PUBLIC INFORMATION SESSION North Main Street Project Peer Review

To:	Town of Sunderland	Date:	June 21, 2018
From:	Lou Rabito Howard Stein Hudson	HSH Project No.:	2017263
		MassDOT File No.:	607245
Subject:	Route 47 (North Main Street) Reconstruction Project – Peer Review Public Information Meeting Meeting Notes of June 11, 2018

Route 47 (North Main Street) Reconstruction

Option 1: Sidepath (25% Design)

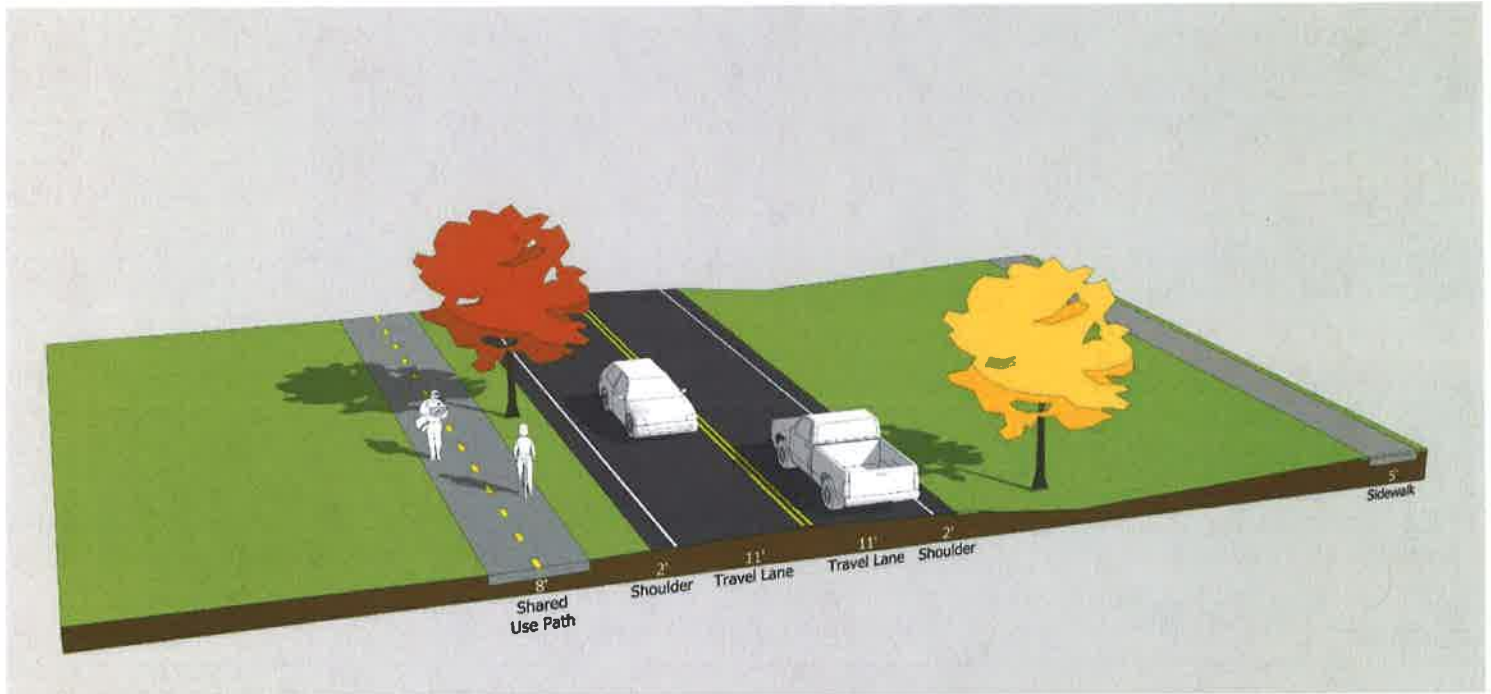
- **8-Foot Sidepath Proposed vs. 10-Foot Shared Use Path**
 - Minimize impacts and low anticipated bike volumes
- **Narrow 2-foot shoulders assist with Traffic Calming**
- **Sidewalk on east side to be re-built**
- **Several large mature trees along corridor**
 - Care should be taken when working within the root zone of these trees.
 - Consult with MA Certified Arborist and Town Tree Warden
- **New sidewalk proposed north of North Silver Lane**
 - 5-foot sidewalk with 5-foot grass buffer
 - Utility pole placement should be evaluated as they are within the clear zone.

Item	Benefits	Challenges
Option 1 25% Design	Sidepath covers bike and ped accommodations in the same space.	Addition of sidepath reduces existing green space along the roadway.
	Minimal roadway widening	Potential for more tree impacts than what is shown on the plans
	A narrower roadway cross section can act as a traffic calming measure.	Concern about utility poles being too close to the edge of pavement.
	Proposed design fits without requiring the addition of vertical curb (and subsequent drainage system).

Option 2: Bicycle Lanes

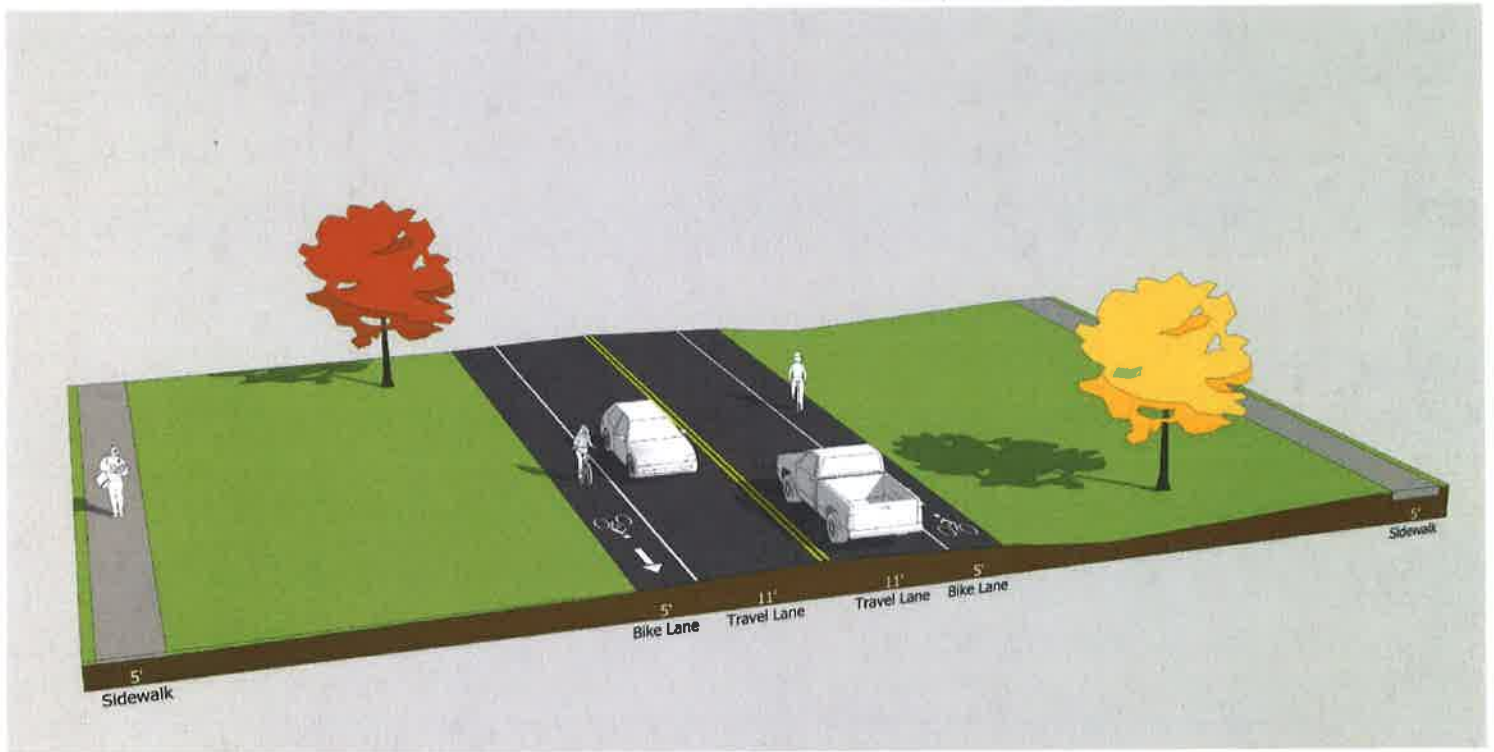
- **Standard 11-foot travel lanes with 5-foot bike lanes**
- **Widens road 3-feet on each side (32-feet curb to curb)**
- **Wider roadway may lead to higher operating speeds**
- **Visual Impact of wider roadway**
- **Still requires updated sidewalk on west side**
 - Potential for tree impacts when rebuilding sidewalk
- **Widening north of North Silver Lane:**
 - Sidewalk needs to be shifted to avoid need for curb
 - Additional permanent easements may be needed for grading
 - Utility poles should be relocated further from road

Item	Benefits	Challenges
Option 2: 11' Lanes & Bike Lanes	Dedicated on-street bike lanes	Requires the roadway cross section to widen by 3-feet on each side.
	Reduces the visual impact to green space caused by the sidepath.	Still requires a proposed sidewalk on the west side (unless a design exception was granted).
		Visual impact of a 32-ft vs. 24-ft wide road will be greater than that of an 8-ft path vs. 5-ft sidewalk.
		A widened roadway may require shifting of utility poles and the proposed sidewalk north of North Silver Lane unless curb is added.
		Potential tree impacts.
		Adds cost from additional full depth pavement. (Not including add utility pole relocations if needed).

Option 3: 10-foot Lanes + Bicycle Lanes

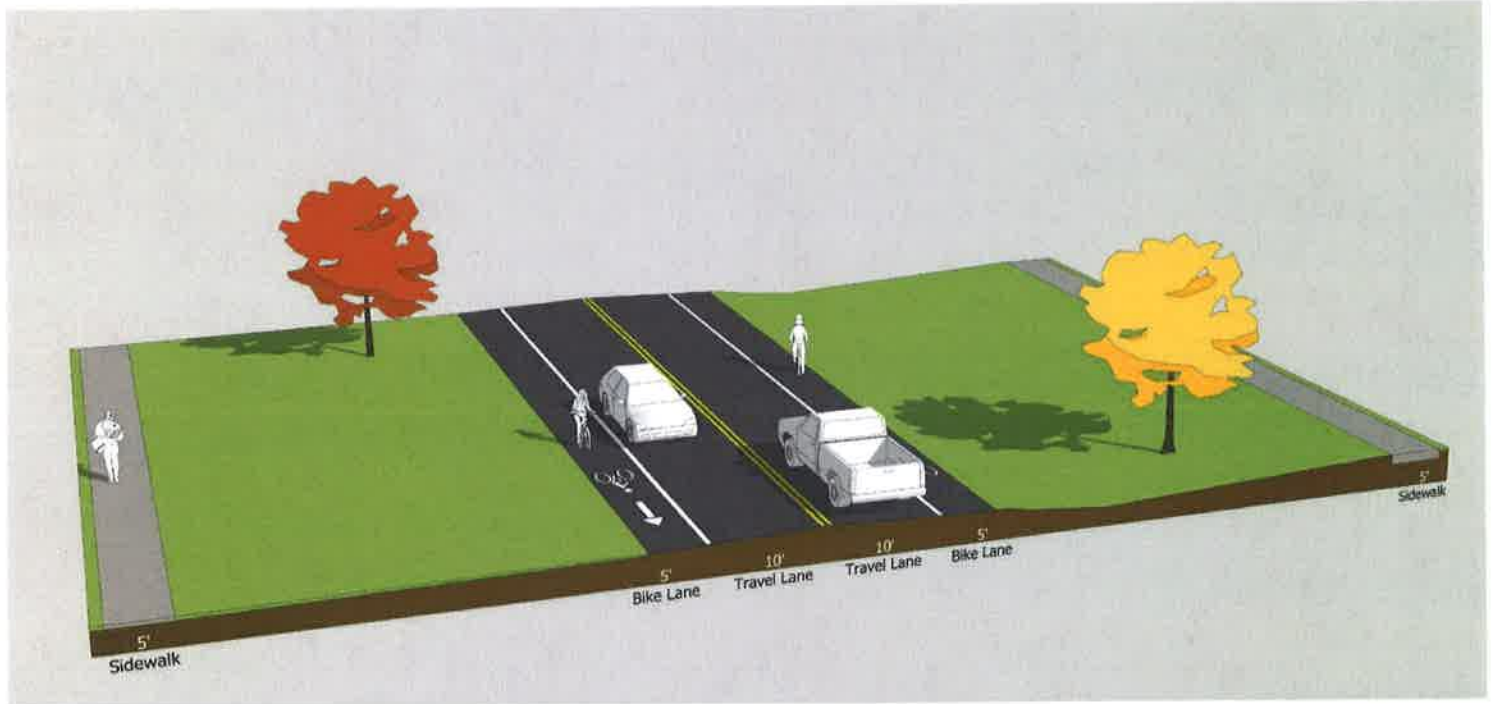
- **Narrow 10-foot travel lanes with 5-foot bike lanes**
 - Requires Design Exception
- **Widens road 2-feet on each side**
- **Narrow travel lanes help provide traffic calming**
- **Lesser visual impact**
- **Still requires updated sidewalk on west side**
 - Potential concerns for tree impacts
- **Widening north of North Silver Lane:**
 - Sidewalk needs to be shifted to avoid vertical curb
 - Additional permanent easements may be needed for grading
 - Utility poles should be relocated further from road

Item	Benefits	Challenges
Option 3: 10' Lanes & Bike Lanes	Dedicated on-street bike lanes	Roadway would widen by 2-feet on each side.
	Reduces the visual impact to green space caused by the sidepath.	Still requires a proposed sidewalk on the west side (unless a design exception was granted).
	Narrow travel lanes act as a traffic calming measure	A widened roadway may require shifting of utility poles and the proposed sidewalk north of North Silver Lane unless curb is added.
		Potential for tree impacts from proposed sidewalks

Option 4: No Bicycle Accommodations

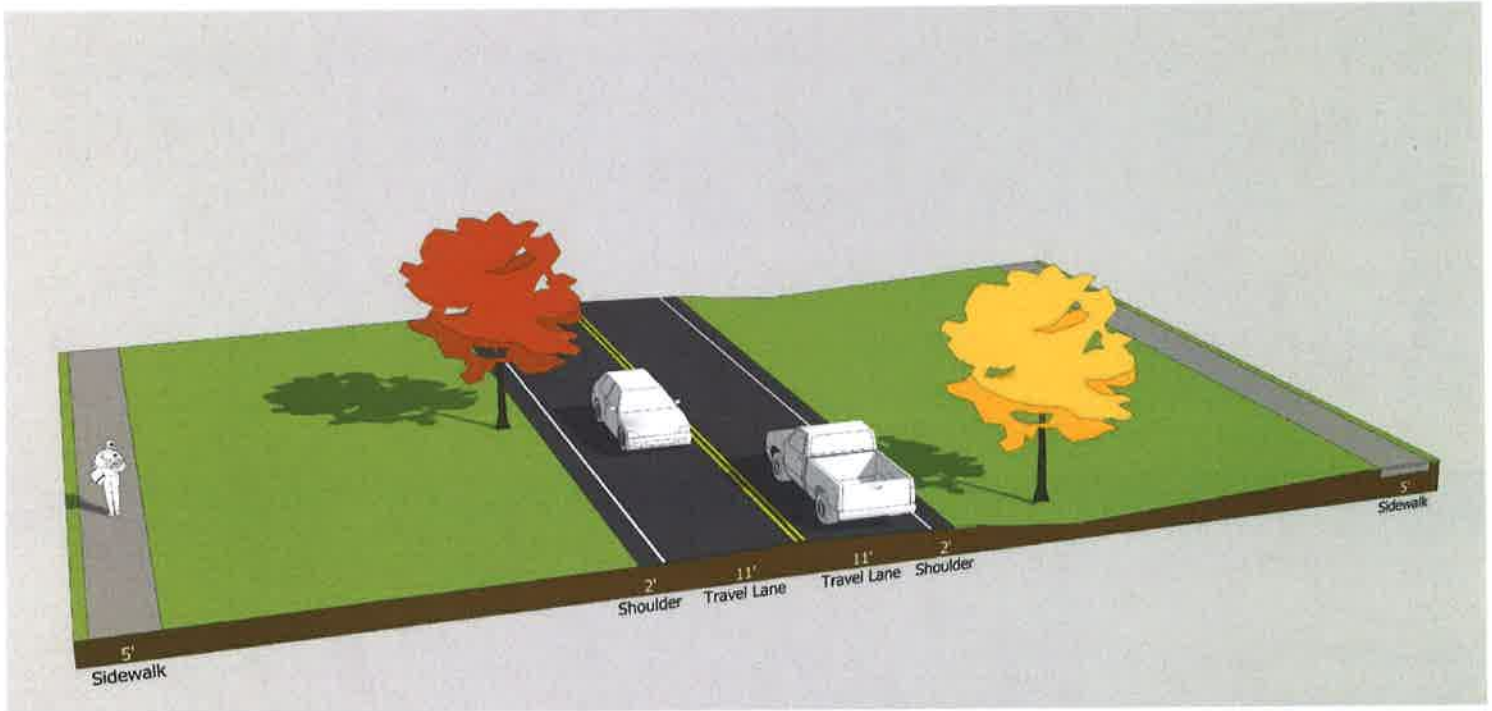
- **Removes the 8-foot sidepath**
- **Proposed 11-foot lanes and 2-foot shoulder**
- **Narrow roadway helps reduce speeds**
- **Least amount of physical and visual impact**
- **Still requires updated sidewalk on west side**
 - Potential for tree impacts
- **Requires Design Exception for not providing bicycle accommodations.**
 - Unlikely that MassDOT would grant this waiver given the size of the corridor and available ROW.

Item	Benefits	Challenges
Option 4 No Bike Accommodations	Minimal roadway widening & no sidepath reduces impacts (physical and visual).	Does not provide bike accommodations.
	Decreases costs a small amount by going from an 8-foot sidepath to a 5-foot sidewalk.	Still requires a proposed sidewalk on the west side (unless an additional design exception was granted).
		Design Exceptions req'd from MassDOT
		Potential for tree impacts from proposed sidewalks.

Option 1 vs. Option 3

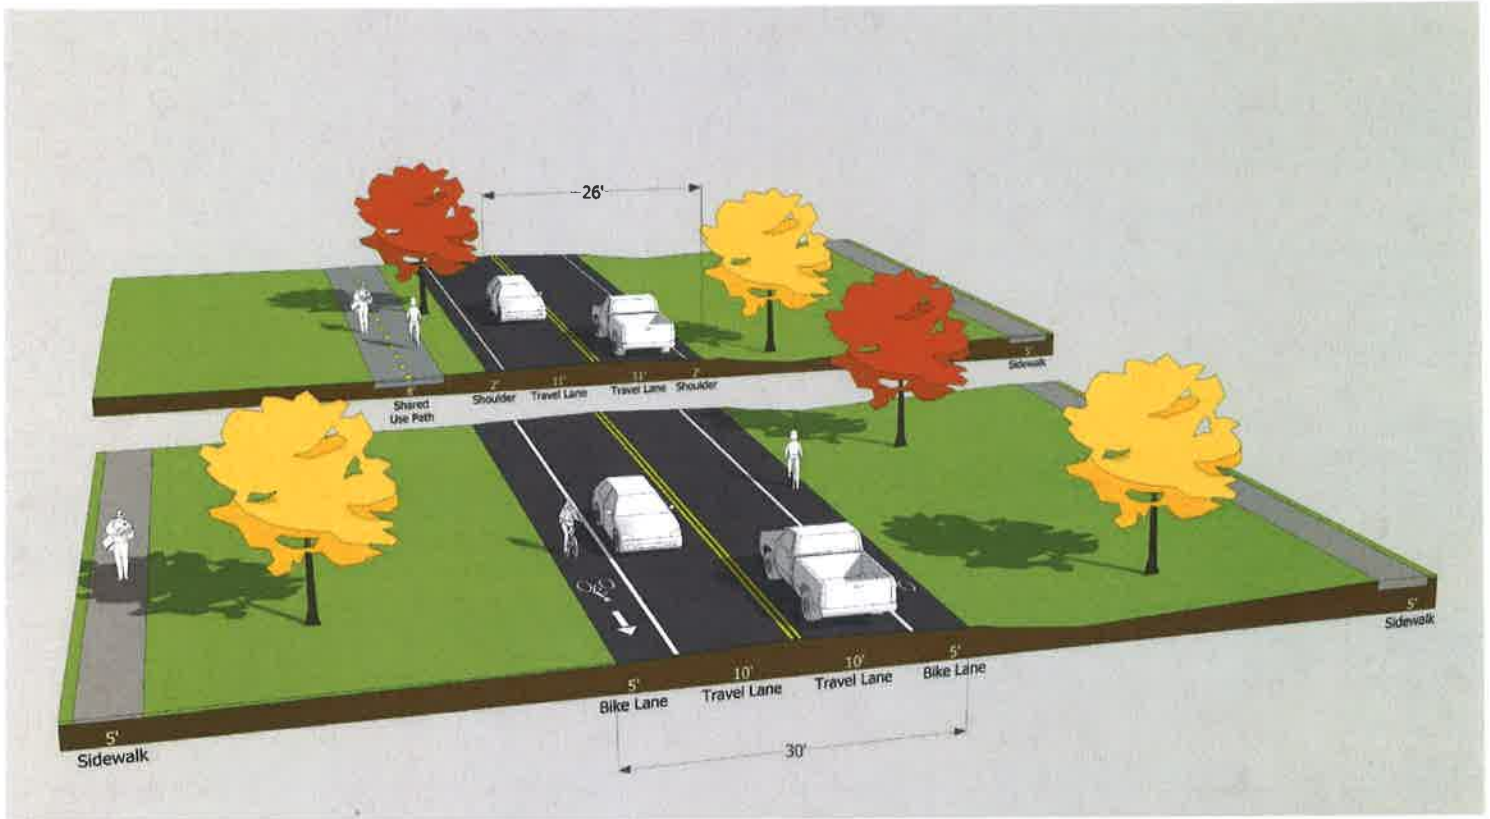
- **Option 3 results in best compromise between what the Town is looking for and what MassDOT would allow.**
- **New sidewalk on west side does not need to be located next to roadway.**
 - The sidewalk can meander away from roadway where space allows
 - The goal would be to place in location that results in least amount of tree impacts.
